ADDENDUM NO. 2
City of Madison, Engineering Division

CONTRACT NO. 9361
STATE STREET CAMPUS GARAGE MIXED-USE PROJECT

This addendum is issued to modify, explain or correct the original Drawings, Specifications, or Contract Documents marked as **State Street Campus Garage Mixed-Use Project, Contract #9361, as issued on October 2, 2023** and is hereby made a part of the contract documents.

S1005-1

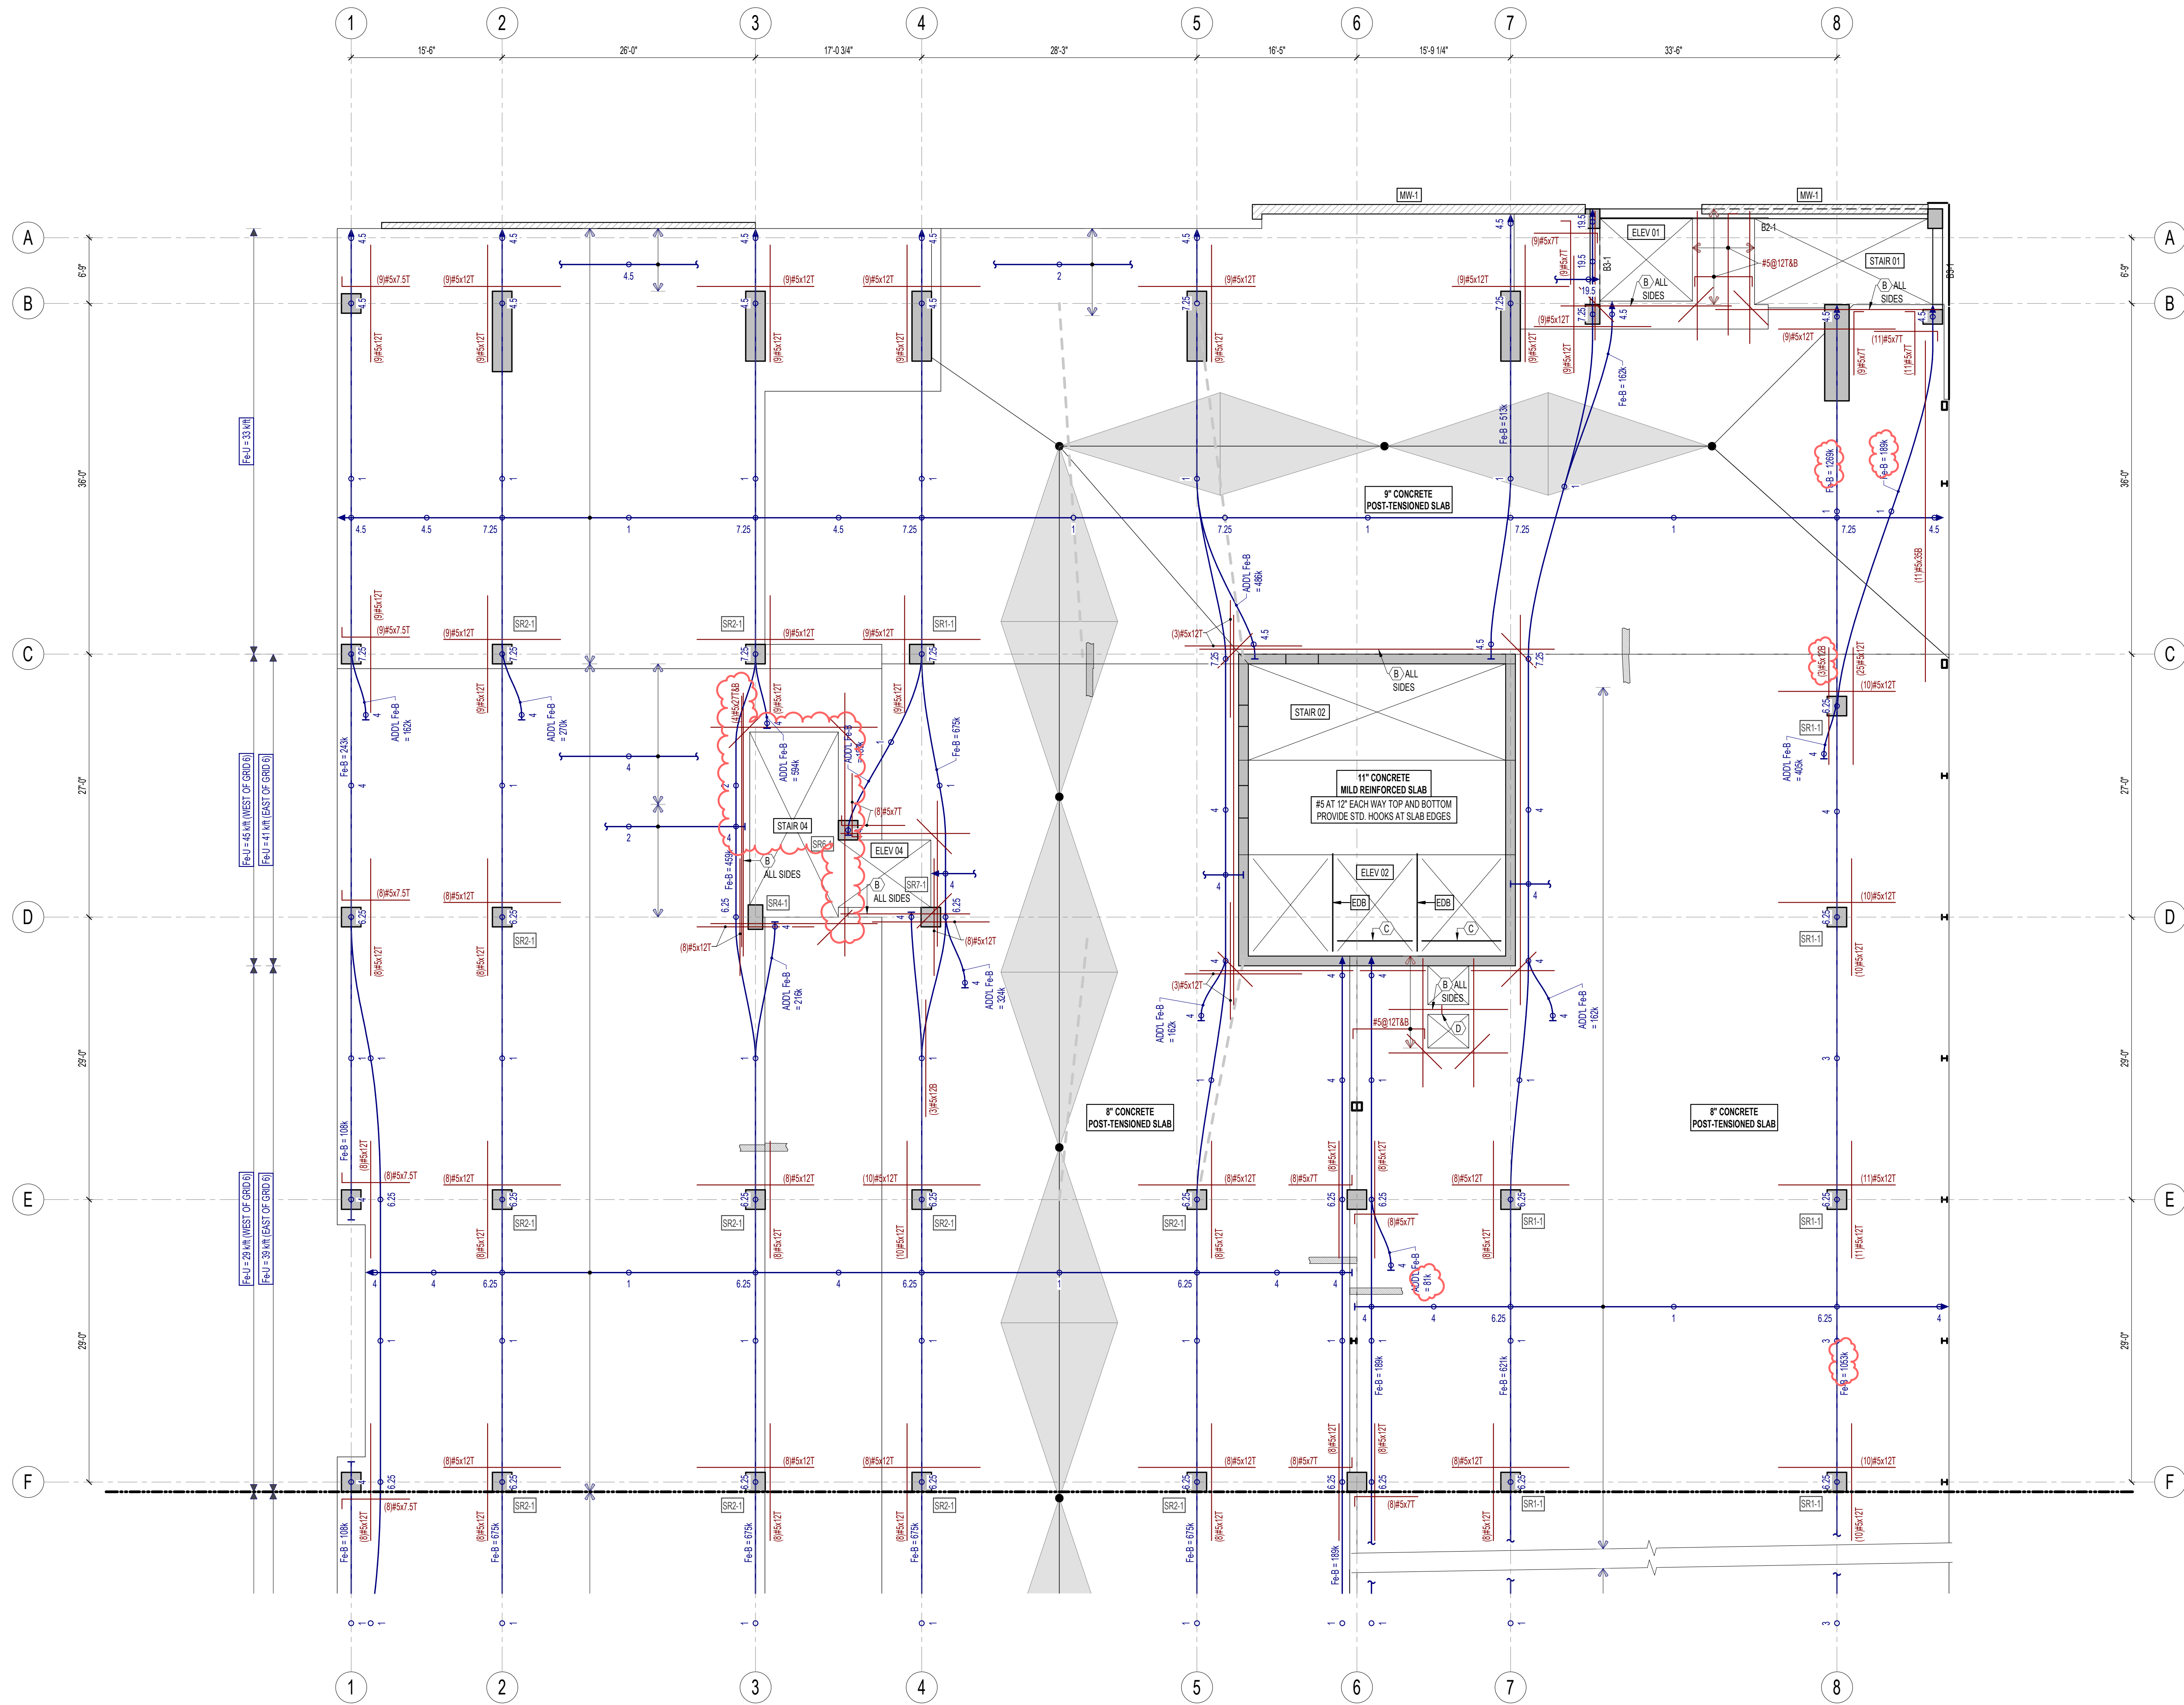
- S1005-1 P5 FLR FRAMING PLAN – Overall – PHASE 1
 REMOVED detail 2/S4021-1
 ADDED detail cut callout at beams
 ADDED slab diagrams

REVISED "typ" note at detail 3/S4021-1
